## Exhibit A-1

Cleanroom Facilities

Revision #2

# New England Compounding Center proposed Cleanroom Facility Without HVAC Control REVISION #2

A revised sketch A of the proposed floor plan is attached. This revision increases the size of the personnel anteroom.

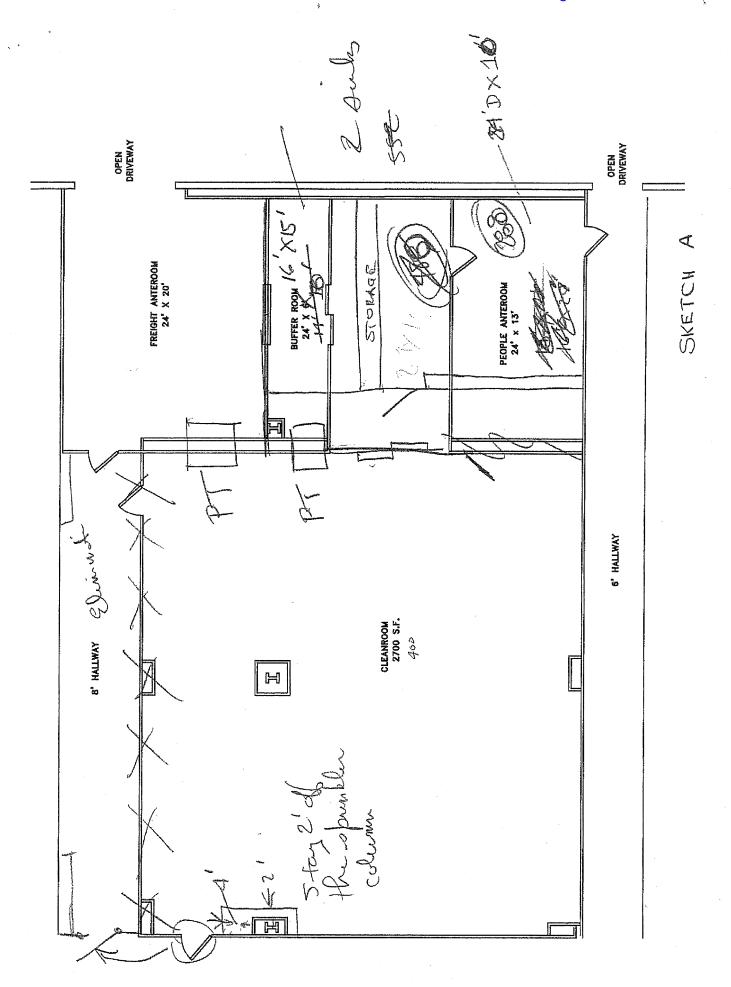
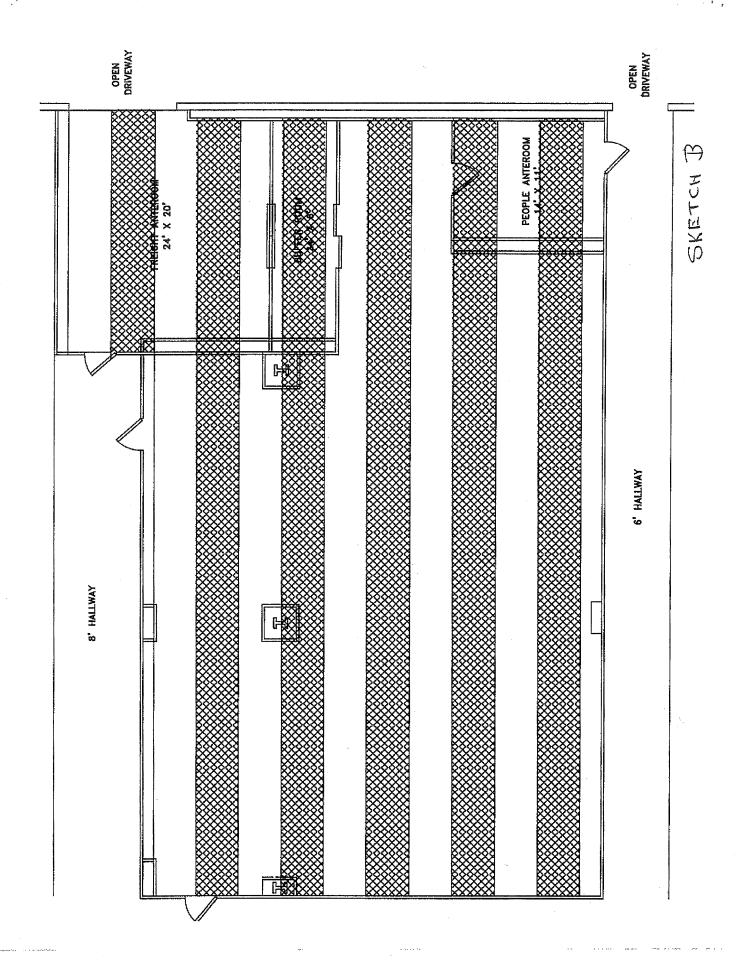
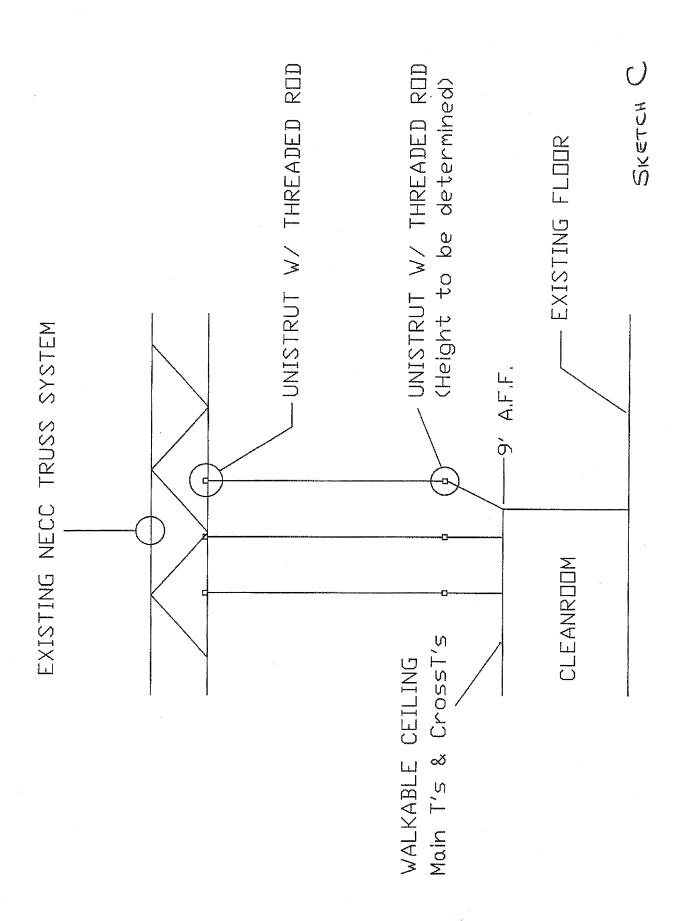
An increased personnel anteroom size.

Walkable Grid Joint

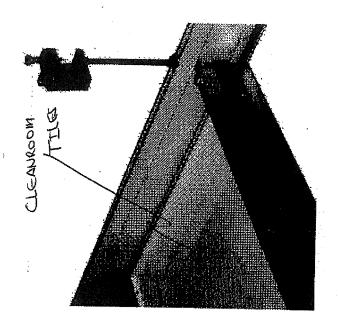
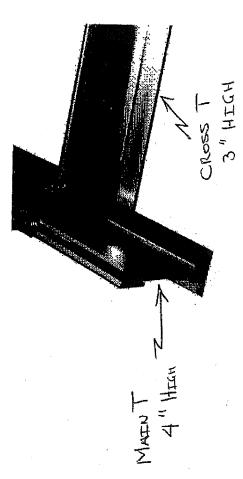
An integral grid system suitable for walkable ceiling applications shall consist of 2" wide white tees and anodized aluminum wall angles. Closed cell urethane foam gasket material shall be applied to all tee bars and wall angles. The main tees of the ceiling grid will support rows of safety grating covering roughly 50 % of the ceiling area. Sketch B attached depicts the coverage. The ceiling grid is supported by an array of threaded rod and Unistrut as shown on sketch C and the safety grating will be positioned on top of the 4" high main tees. Sketch D is attached to enhance the explanation of the design concept.

SAFETY GRATING WILL BE PLACED ON TOP OF 4" HIGH MAIN T'S
